ARIZONA DEPARTMENT OF ENVIRONMENTAL QUALITY

March 12, 2008

Re: Mitigation Order on Consent, Docket No: P-121-07- Work Plan

SULFATE CONCENTRATION MAP - JULY 1989
CONCENTRATOR TAILING STORAGE AREA AND VICINITY
BISBEE, ARIZONA

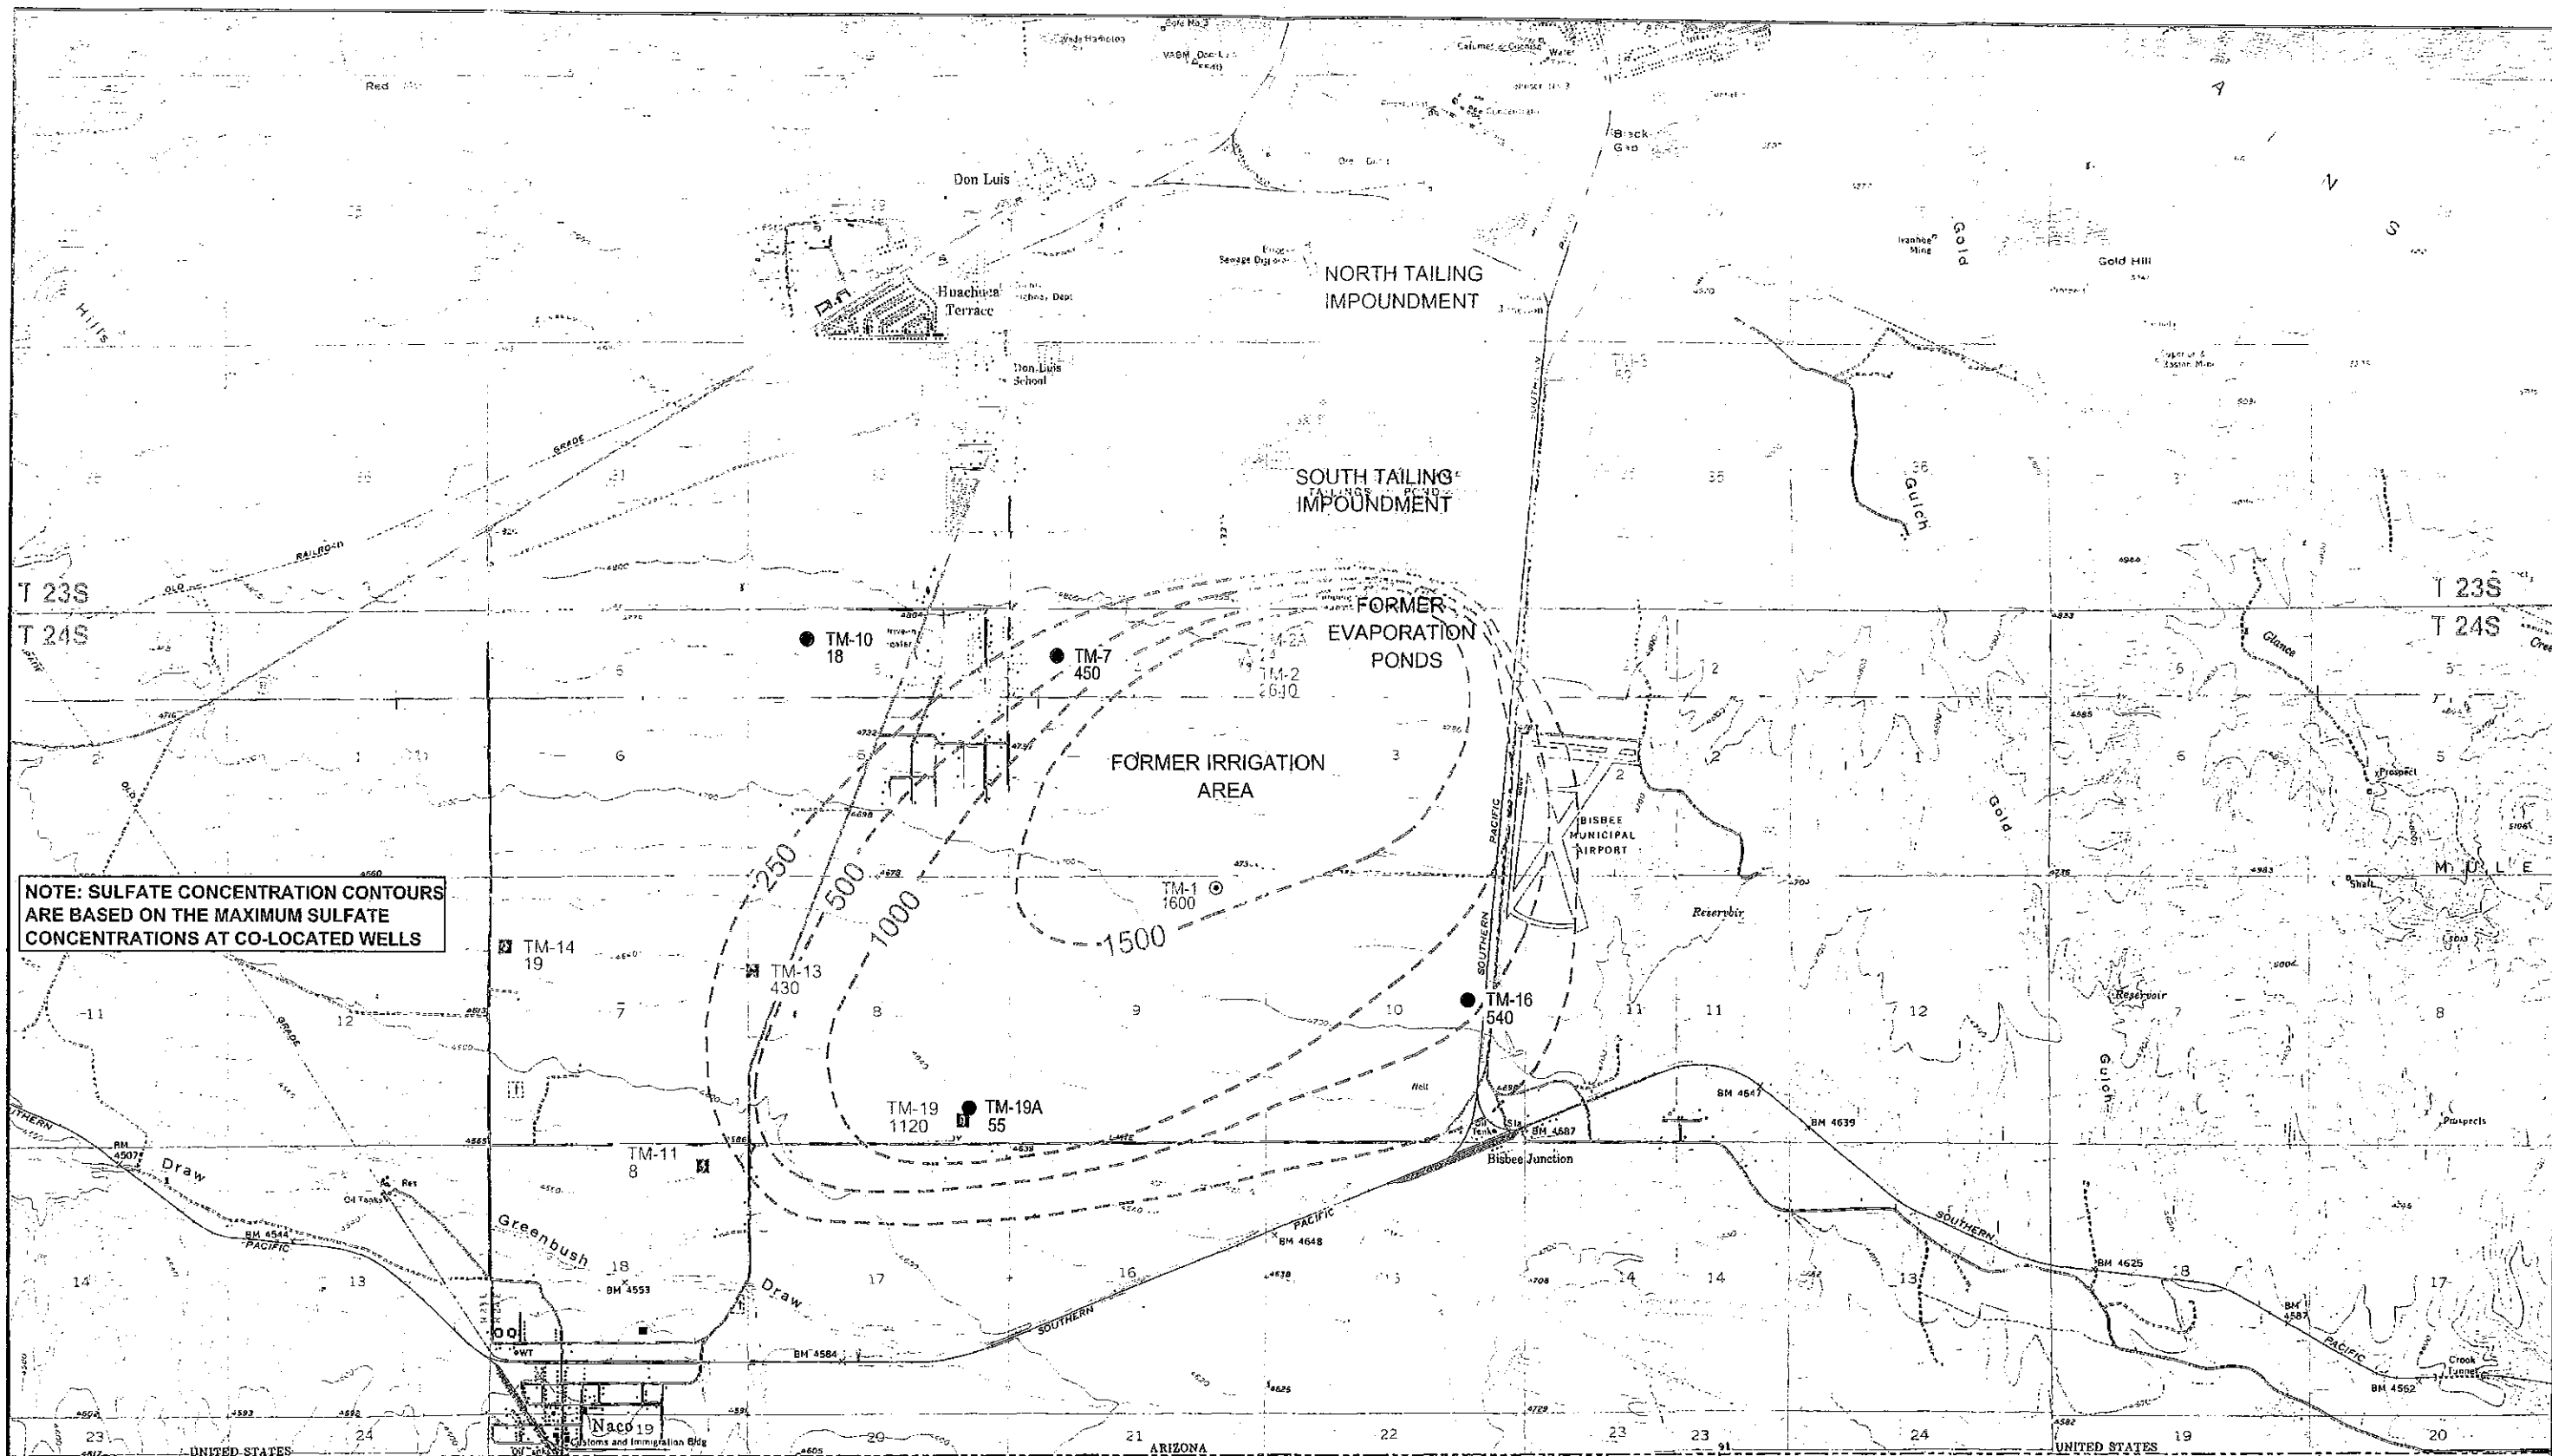
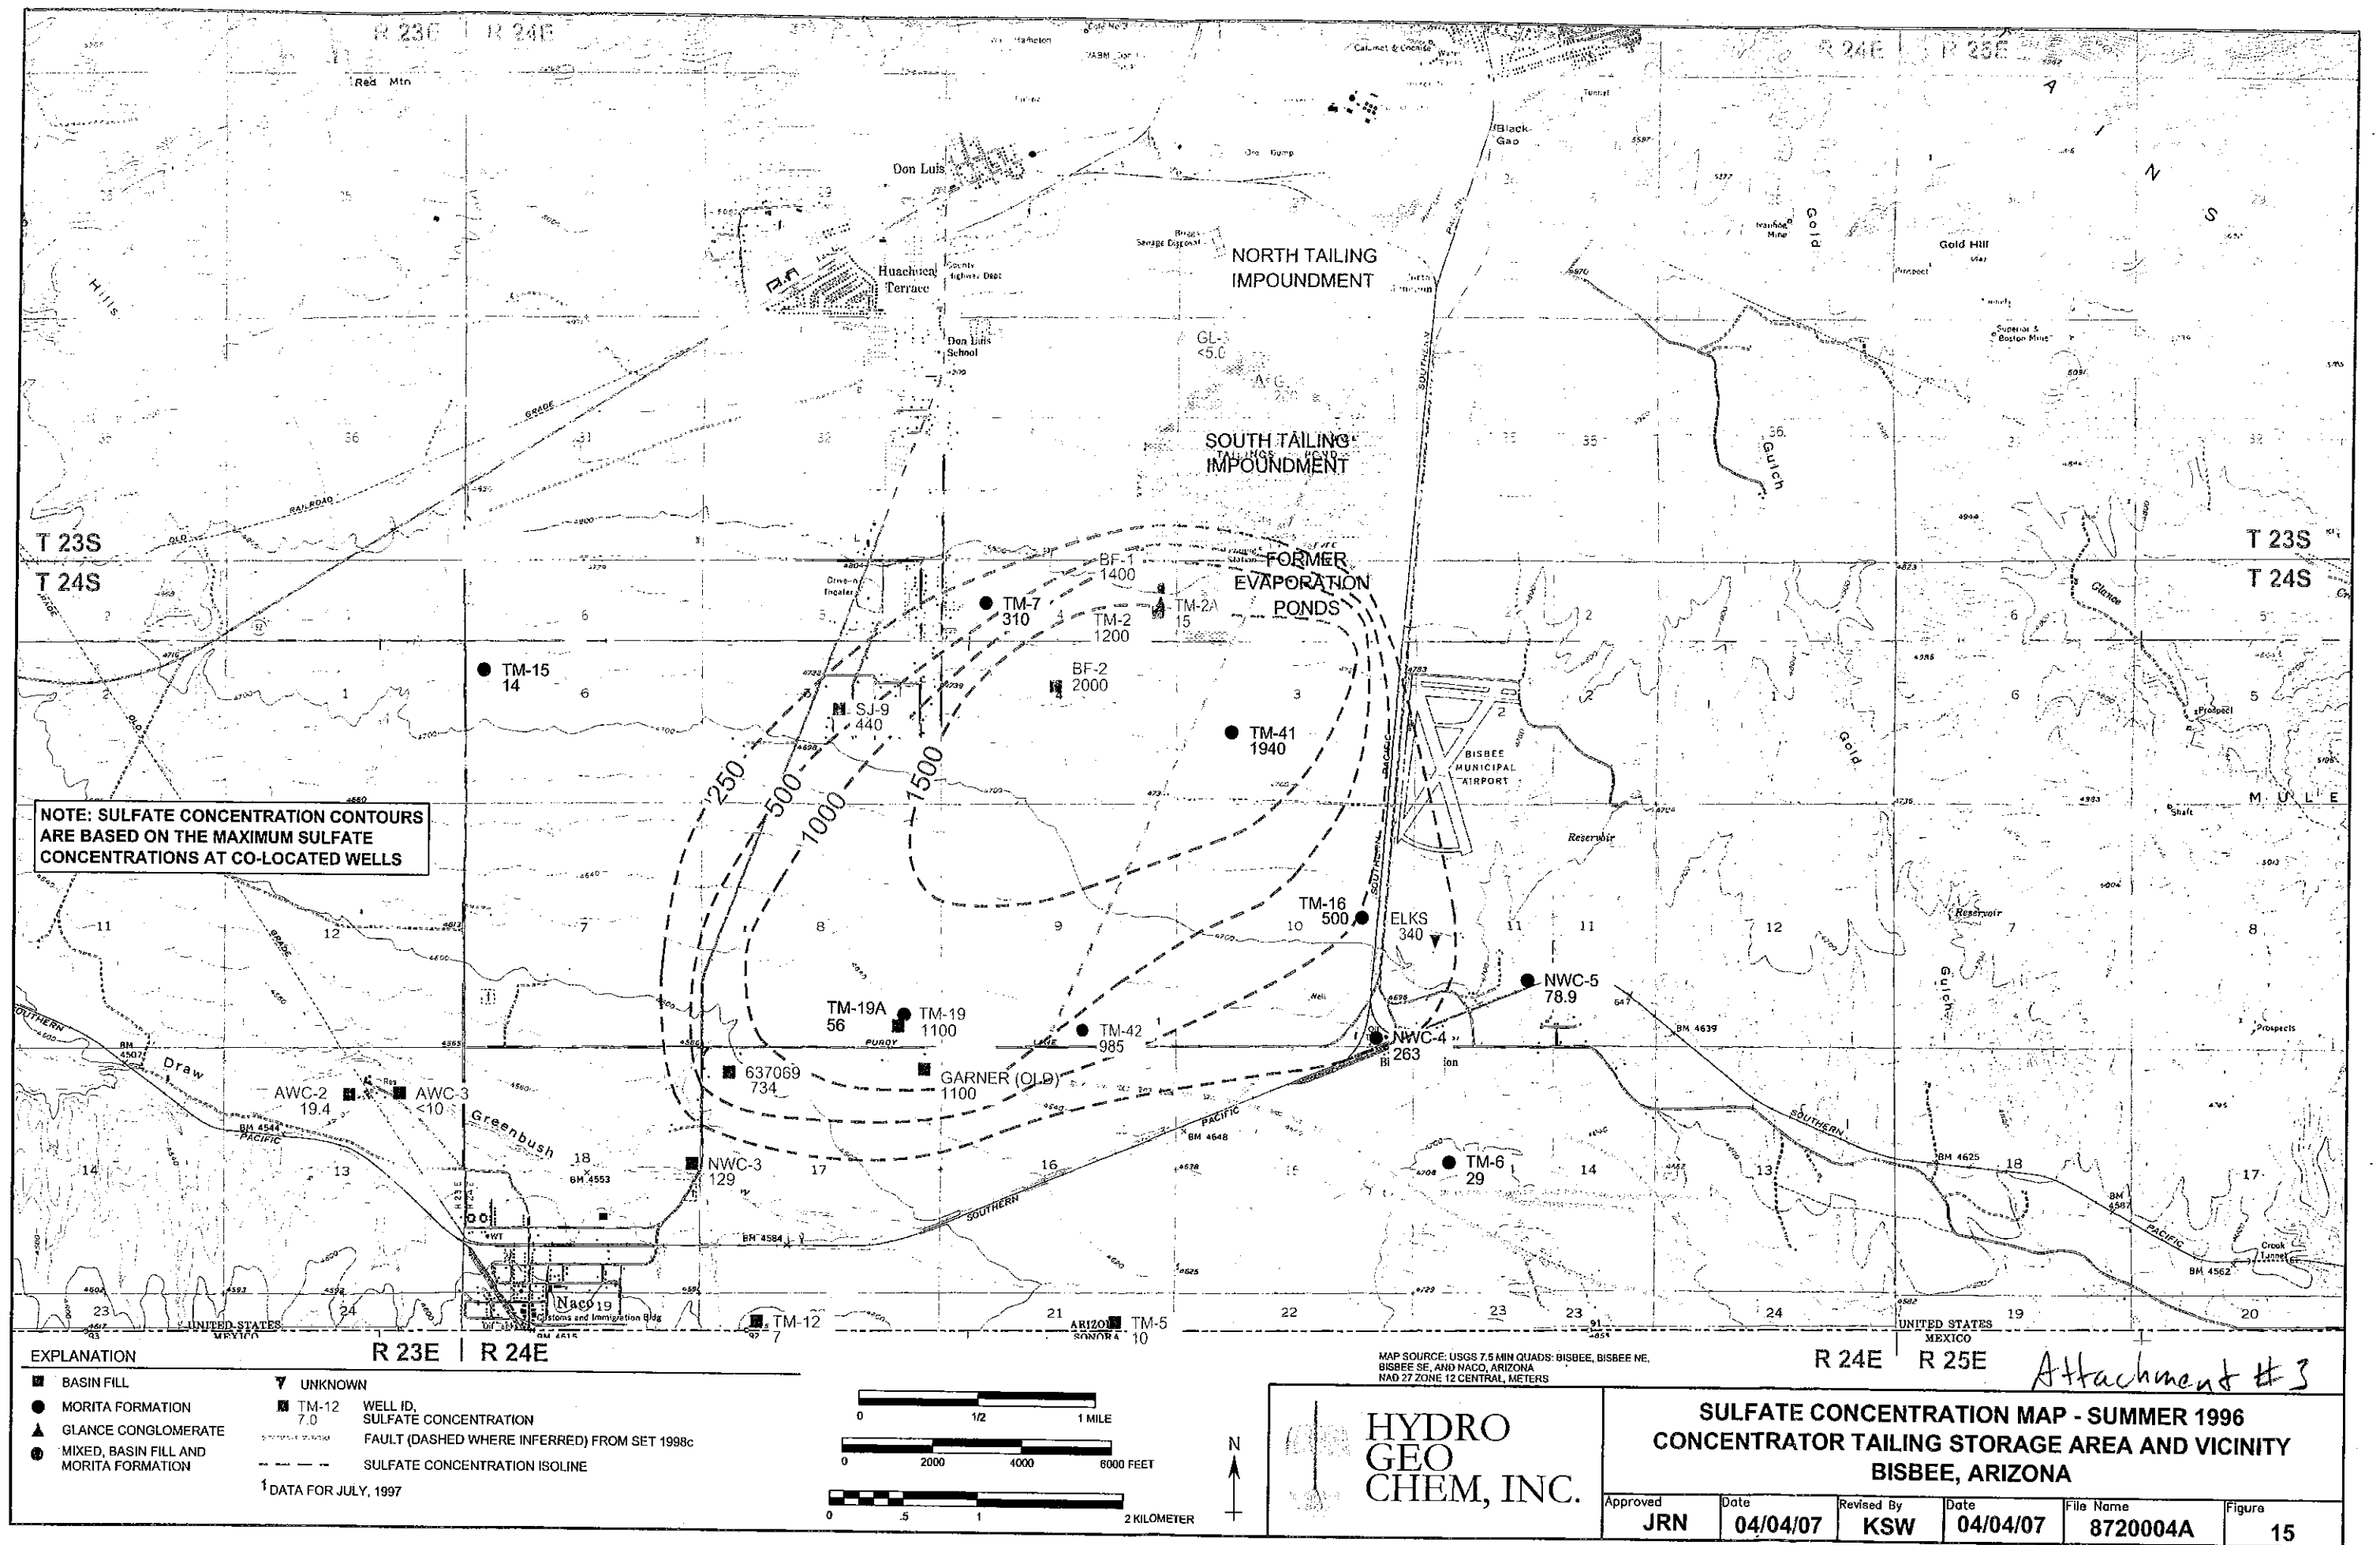
- a. This section provides an estimation of the current extent of the sulfate plume based upon limited 2005 groundwater sampling and inferences from the 1996 groundwater sampling. It estimates the sulfate plume as being "approximately 3.5 miles long in a southwesterly direction and 2.5 miles wide, with its northern boundary located at the southern margin of the South Tailing Impoundment and its southern edge south of Naco Water Company (NWC) well 3 (NWC-3) (Figure 4)." Based upon data presented in Figure 4 "Sulfate Plume, 2005 Approximate Boundary of 250 mg/L Sulfate Concentration, Bisbee, Arizona," Attachment #1, ADEQ believes that the sulfate plume is probably slightly longer than depicted. Well NWC-3 had a sulfate concentration of 390 mg/L, while the work plan shows the 250 mg/L contour as being right next to the well. The contour should be at some distance beyond well NWC-3. See Attachment #1 for ADEQ's reconfiguration of the maximum extent of sulfate contamination. This is based upon the limited data collected and reviewing data presented in Figure 14, "Sulfate Concentration Map – July 1989," and Figure 15, "Sulfate Concentration Map – Summer 1996," Attachments #2 and #3, respectively.
